Project	<b>IEEE 802.16 Broadband Wireless Access Working Group</b> < <a href="http://ieee802.org/16">http://ieee802.org/16</a> >	
Title	<b>Clarification on transmitter structure for MIMO precoding</b>	
Date Submitted	<b>2005-01-11</b>	
Source(s)	Qinghua Li, Xintian Eddie Lin, Alexei Davydov, Nageen Himayat, Minnie Ho, Sumeet Sandhu, Randall Schwartz, Jose Puthenkulam	<a href="mailto:qinghua.li@intel.com">qinghua.li@intel.com</a> Voice: +1-408-765-9698
	<b>Intel Corporation</b>	
Re:		
Abstract		
Purpose	Adoption of proposed changes into P802.16e <del>Crossed out indicates deleted text,</del> <u>underlined blue indicates new text change to the Standard</u>	
Notice	This document has been prepared to assist IEEE 802.16. It is offered as a basis for discussion and is not binding on the contributing individual(s) or organization(s). The material in this document is subject to change in form and content after further study. The contributor(s) reserve(s) the right to add, amend or withdraw material contained herein.

# Clarification on Transmitter Structure for MIMO Precoding

**Figure 251h Illustration of Matrix C with vertically encoding for optional zones in DL.**

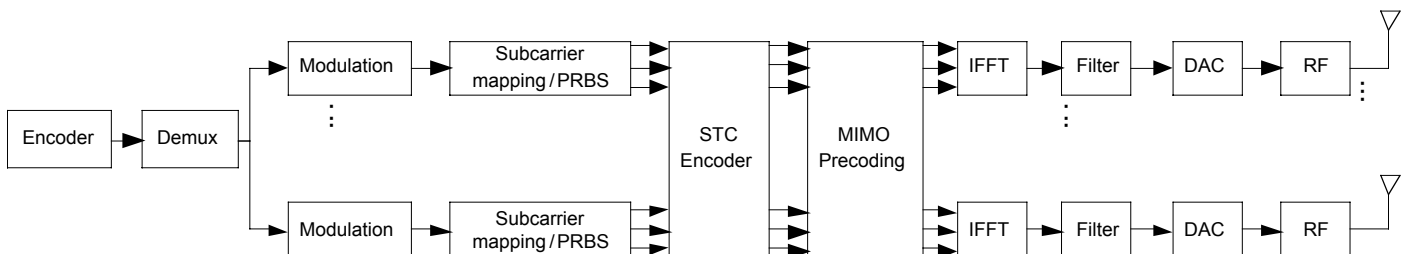
The simple solution to these problems is to allow the number of STC output not equal to the number of transmit antennas. A MIMO structure for the combination of STC and MIMO precoding is proposed to add in section 8.4.8.3.6. Corresponding to the open loop structures for STC Matrix C in figure 251c and 251d, page 336, 16e D5a, a modulation coding scheme (MCS) table is proposed to enable bit loading for closed-loop MIMO (or MIMO precoding). Since the number of entries in the table for up to 4 data streams is less than 64, the MCS can be uniquely specified by a 6 bit index. This enables the feedback of MIMO MCS using 6 bit CQICH, which is supported by contribution 552r3.

*Added at the end (i.e., line 27) in section 8.4.8.3.6 on page 344 of [1] as follows*

[In Figure 251h, the STC encoder can employ any matrixes defined in sections 8.4.8.3.3, 8.4.8.3.4, and 8.4.8.3.5 whose number of output \(i.e. rows\) is equal or less than the number of the BS antennas. The demux assigns bits to multiple data streams according to the modulation employed by the stream.](#)  
[The MCSs at the input of the STC encoder with Matrix C are specified in Table 315.](#)
